**ADDENDUM 3**

**ENVIRONMENTAL IMPACT REPORT**

**MISSION TRAILS FRS II, PIPELINE TUNNEL, AND**

**VENT DEMOLITION PROJECT**

**FIGURE 1**  
**Modified Project Impacts**  
Mission Trails FRS II EIR Addendum 3

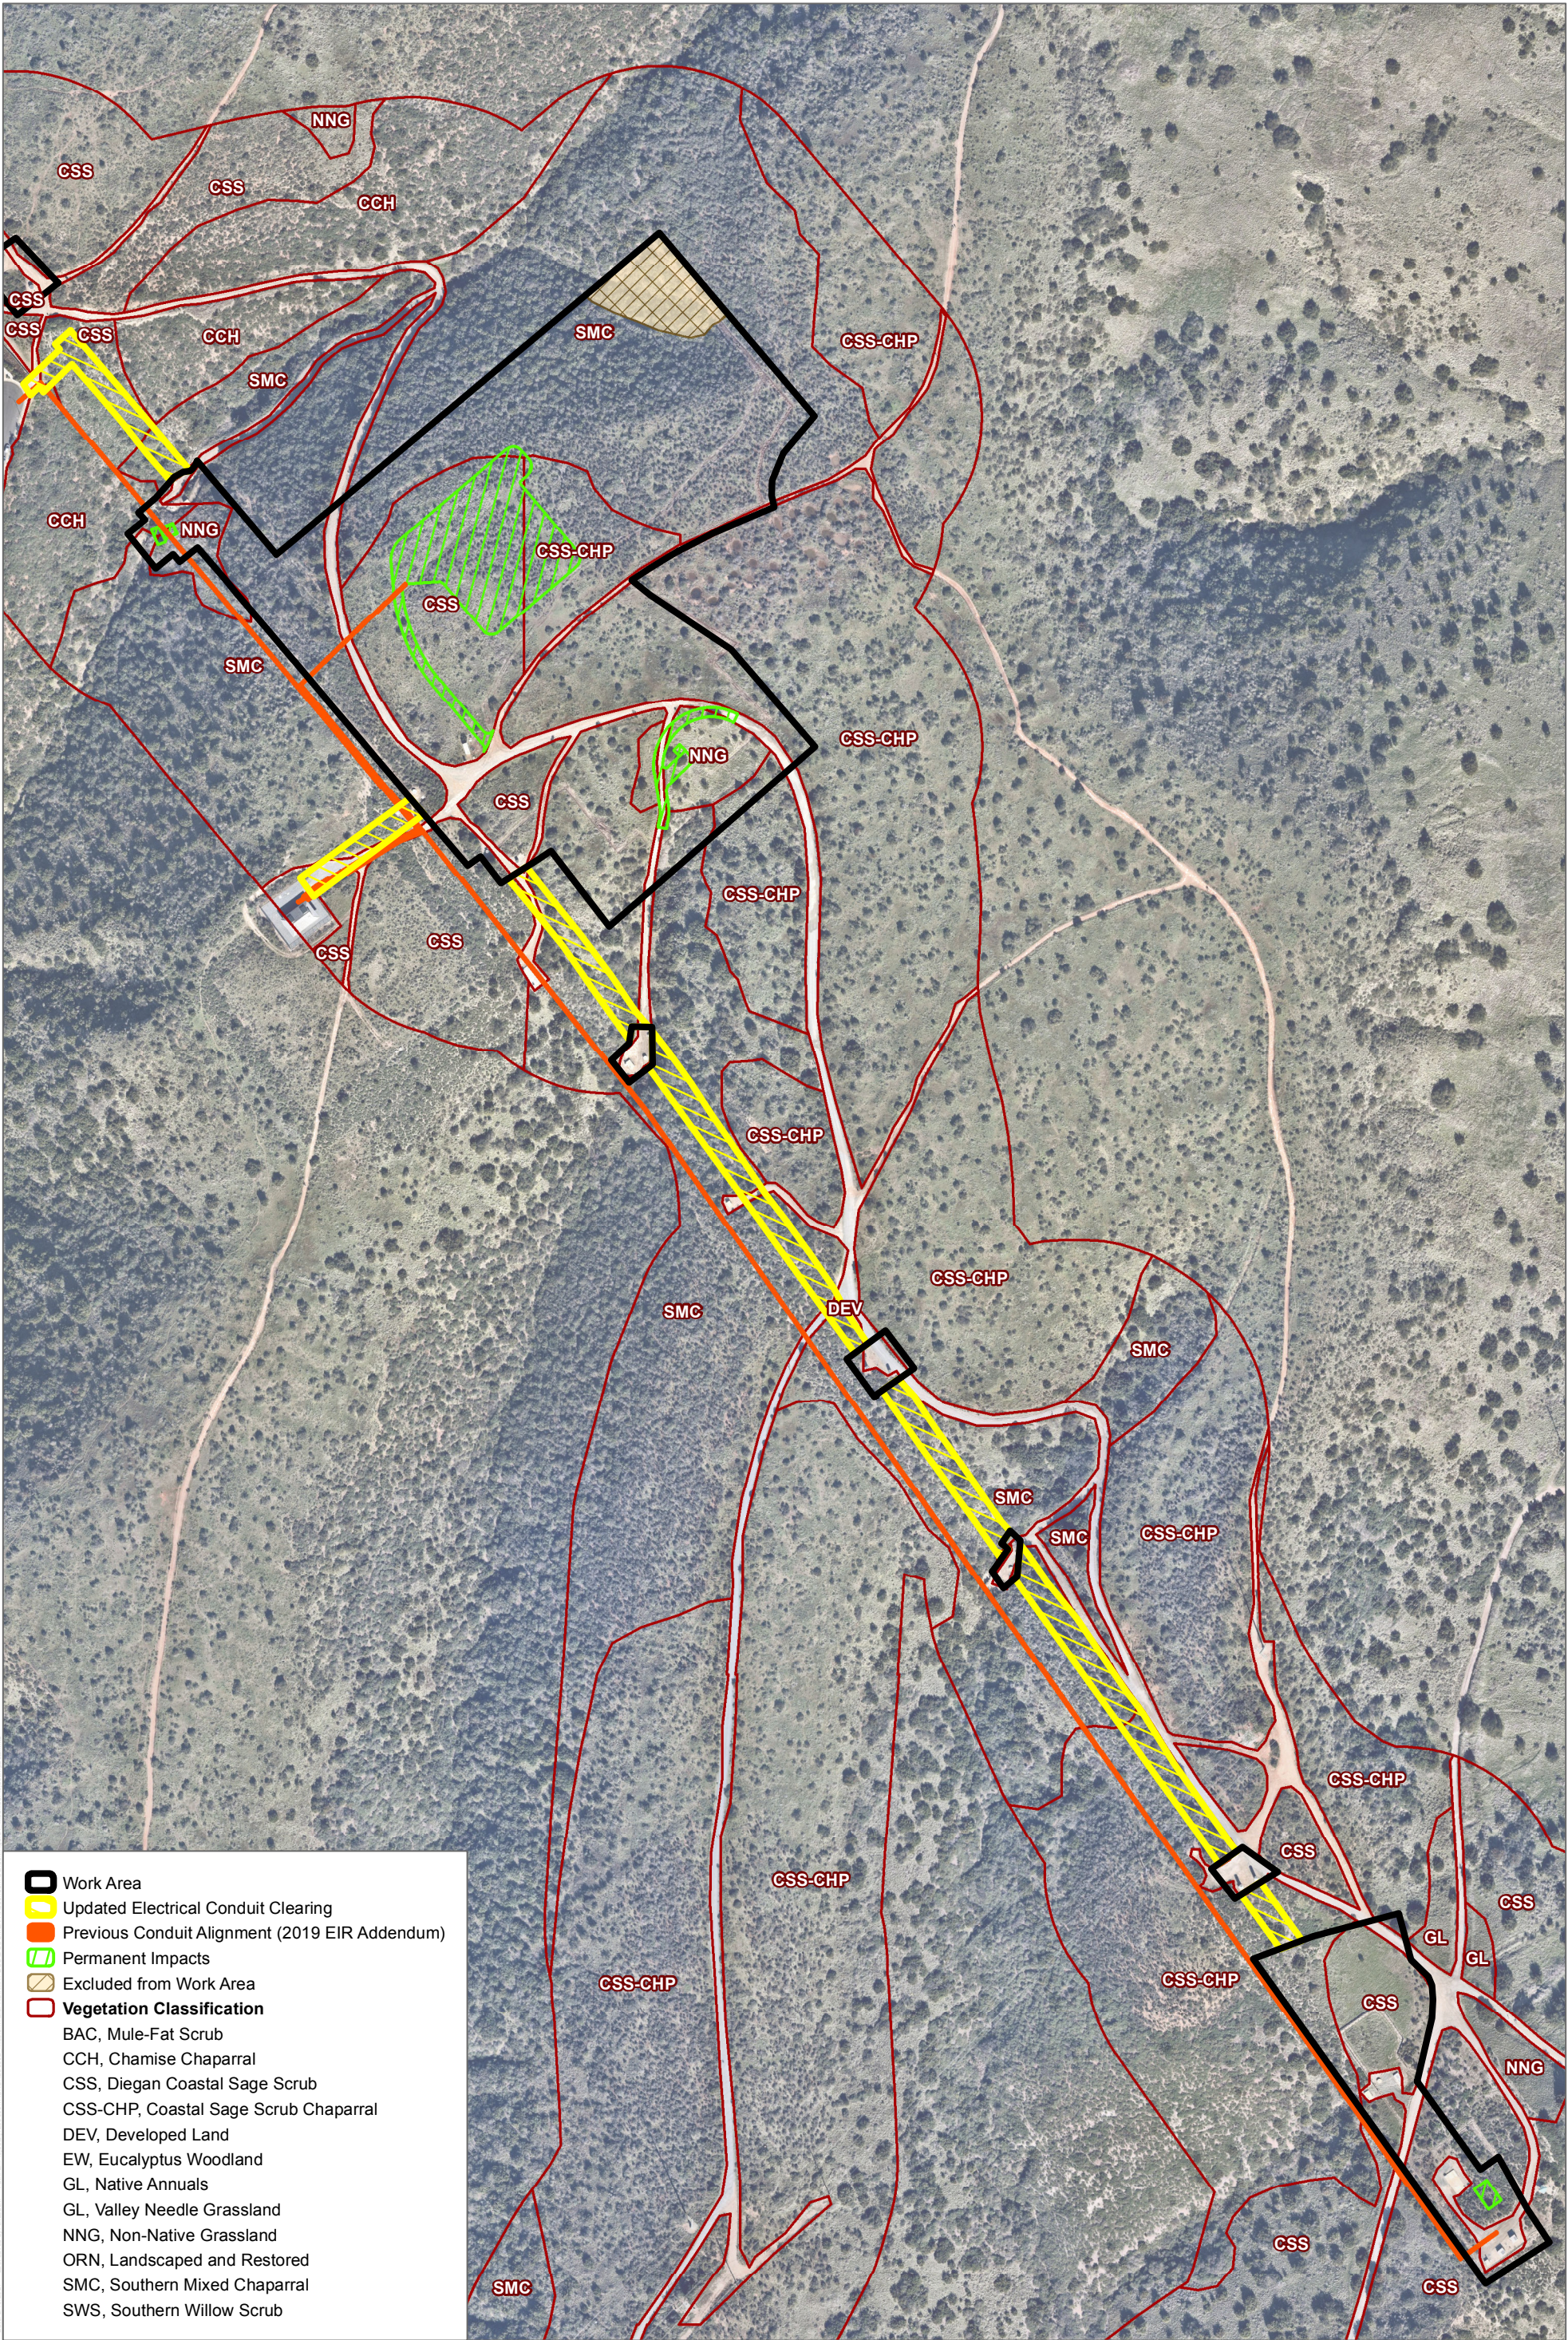
The Water Authority plans to proceed with implementing the electrical conduit as analyzed in the EIR and Addendum 1, but with an increase in width from 5 feet to 40 feet, and a shift in the alignment toward the east. These changes are addressed in this Addendum (Addendum 3) to the 2006 EIR. This revised component of the project is referred to in this Addendum as the "modified conduit alignment." The effects of the proposed changes on the impacts identified for the project in the EIR, Addendum 1, and Addendum 2 are discussed below in Section 3, Environmental Assessment, of this Addendum. The proposed changes occur within the project's impact area considered in the 2006 EIR, and would not result in new impacts or substantially increase the severity of any previously identified impacts. Figure 1, Modified Project Impacts, depicts the modified conduit location and associated temporary work area corridor.

Electrical conduit installation would entail clearing and grubbing the linear conduit work area corridor, followed by excavating trenches approximately 16 inches wide and 30 inches deep to house the conduit duct bank. The conduit alignment is now planned to be shifted to the eastern edge of the Second Aqueduct ROW instead of being installed on the western edge as analyzed in Addendum 2. As previously assumed, trenches would be backfilled following completion of installation, the disturbed areas would be returned to their original conditions, including native habitat restoration pursuant to the Water Authority's NCCP/HCP. The wider corridor resulted in adding approximately 1.98 acres that was not assumed in Addendum 2, but was part of the impact area assumed in the 2006 EIR.

During initial vegetation clearing and fence installation at the main FRS II tank site in January 2020, project biologists identified a narrow drainage located at the northern corner of the site that was within the previously approved work area but was not addressed in the permits obtained by the Water Authority for project-related impacts on jurisdictional waters. The drainage is located at the bottom of steep and densely vegetated slopes, which the Water Authority's construction contractor confirmed could be excluded from their work area for excavating and constructing the FRS II tank. As a result, the project's work area was revised to exclude approximately 0.57 acres in this location, as shown in Figure 1. Considering this reduction with the additional acreage from the wider conduit area, the project's total temporary impact area increased by approximately 1.41 acres.
